Project	IEEE 802.16 Broadband Wireless Access Working Group < <a href="http://ieee802.org/16">http://ieee802.org/16</a> >	
Title	Reply Comment on Key Hierarchy Text for PKMv2 (C802.16e-04/217r1)	
Date Submitted	2004-11-12	
Source(s)	Chulsik Yoon ETRI  161 Gajeong-Dong, Yusong-Gu, Daejeon, KOREA	Voice: +82 (42) 860-6826 <a href="mailto:csyoon@etri.re.kr">[mailto:csyoon@etri.re.kr]</a>
Re:	IEEE 802.16e	
Abstract	Reply comment on the PKMv2 Key Hierarchy text (C802.16e-04/217r1).	
Purpose	Reply comment on the PKMv2 Key Hierarchy text (C802.16e-04/217r1).	
Notice	This document has been prepared to assist IEEE 802.16. It is offered as a basis for discussion and is not binding on the contributing individual(s) or organization(s). The material in this document is subject to change in form and content after further study. The contributor(s) reserve(s) the right to add, amend or withdraw material contained herein.

## Reply Comment on PKMv2 Key Hierarchy (C802.16e-04/217r1)

Chulsik Yoon, ETRI

Figure xx outlines the process to calculate the AK when the authorization process has taken place, but where the EAP based authentication process hasn't taken place, or the EAP method used has not yielded an MSK:

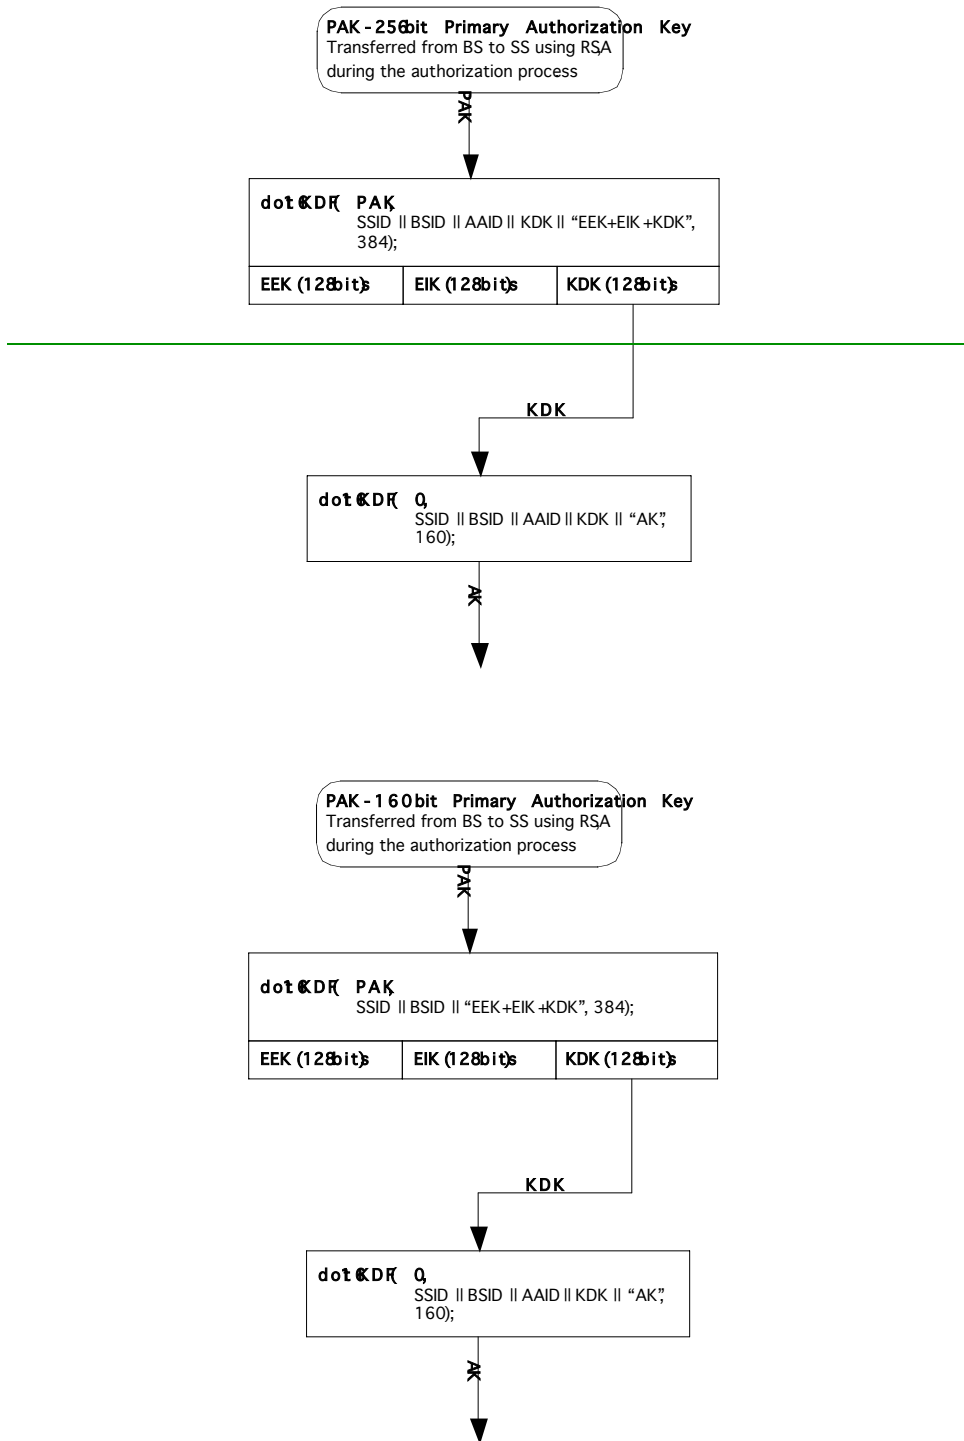
Else if the authorization exchange has been used yielding a PAK and the EAP authentication exchange has been used, but with an EAP method that does not yield key material then the following AK construction shall be used:

$$AK = \text{Dot16KDF}(0, \text{SSID} \parallel \text{BSID} \parallel \text{AAID} \parallel \text{KDK} \parallel \text{"AK"}, 160);$$

Figure xx outlines the process to calculate the AK when both the authorization exchange has taken place, yielding a PAK and the EAP based authentication exchange has taken place, yielding an MSK:

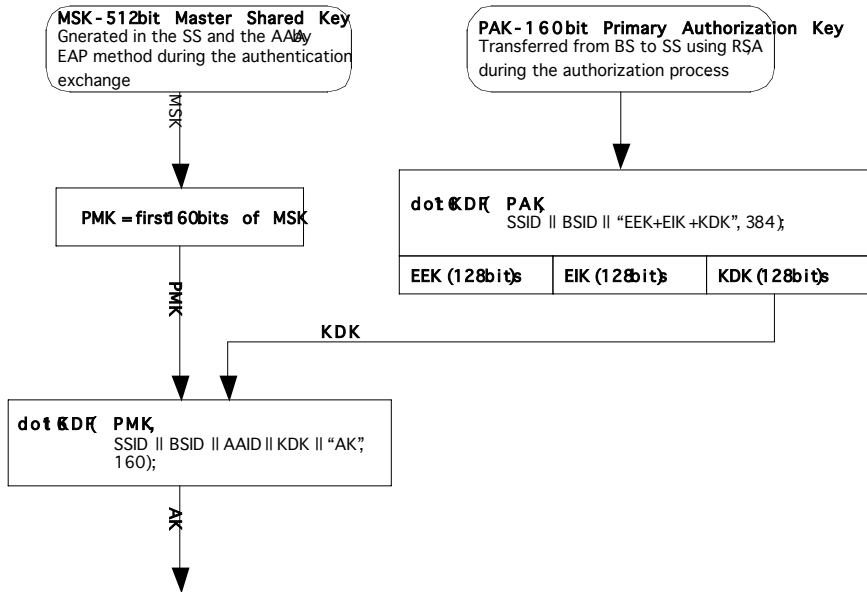
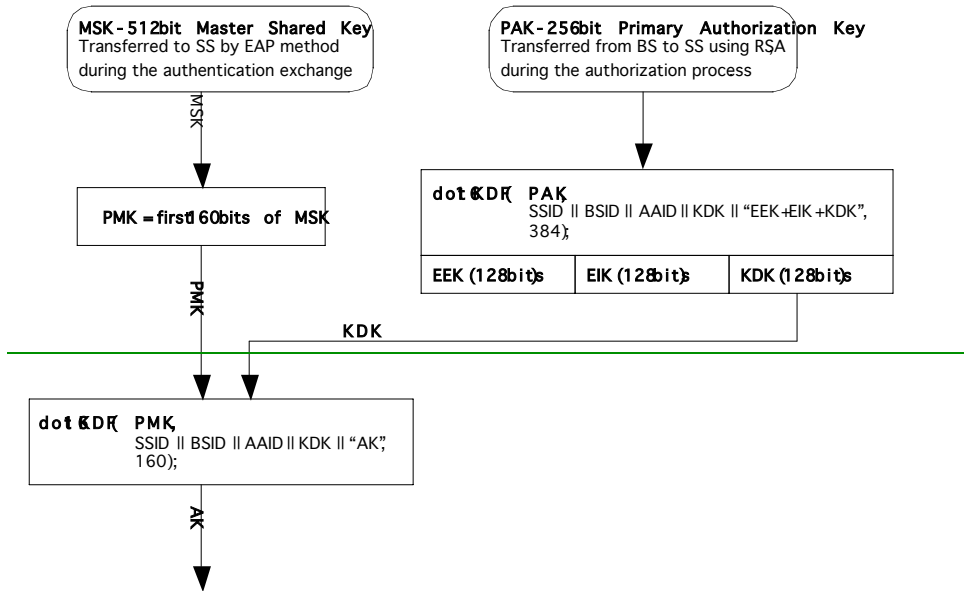
If the authorization exchange has been used yielding a PAK and the EAP authentication exchange has been used, yielding an MSK then the following AK construction shall be used:

$$AK = \text{Dot16KDF}(\text{PMK}, \text{SSID} \parallel \text{BSID} \parallel \text{AAID} \parallel \text{KDK} \parallel \text{"AK"}, 160);$$

Figure xx outlines the process to calculate the AK when only the EAP based authentication exchange has taken place, yielding an MSK:

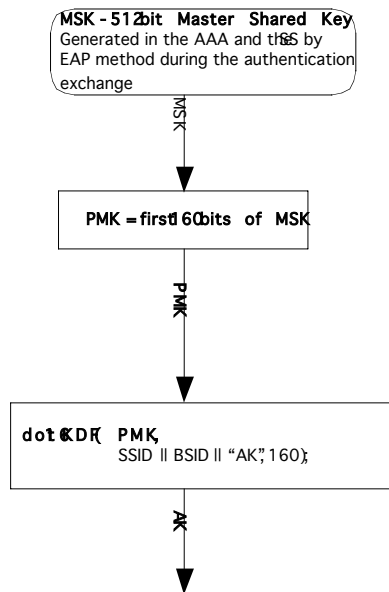
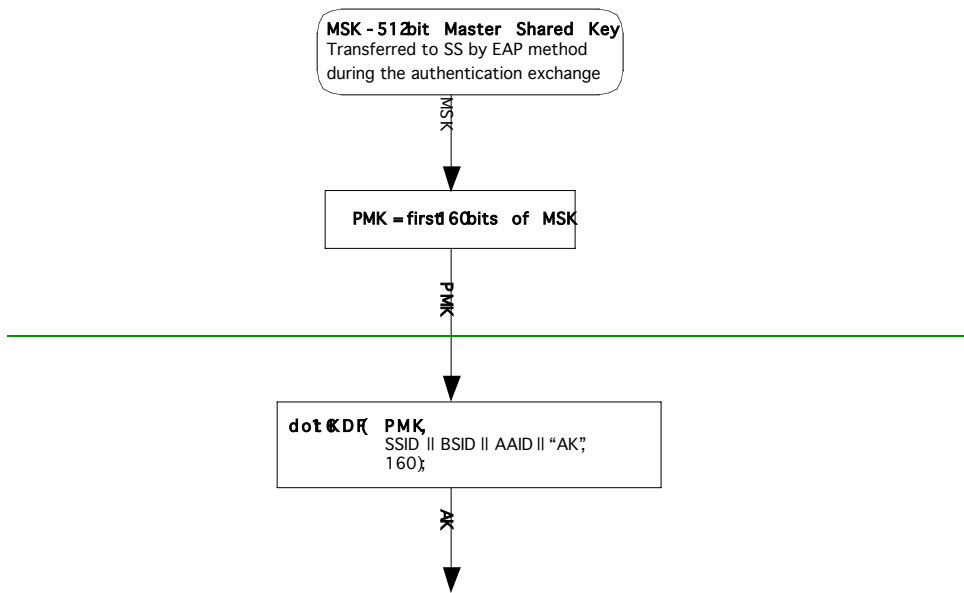
Else if only the EAP authentication exchange has been used, yielding an MSK then the following AK construction shall be used:

$$AK = \text{Dot16KDF}(\text{PMK}, \text{SSID} \parallel \text{BSID} \parallel \del{\text{AAID}} \parallel \text{"AK"}, 160);$$
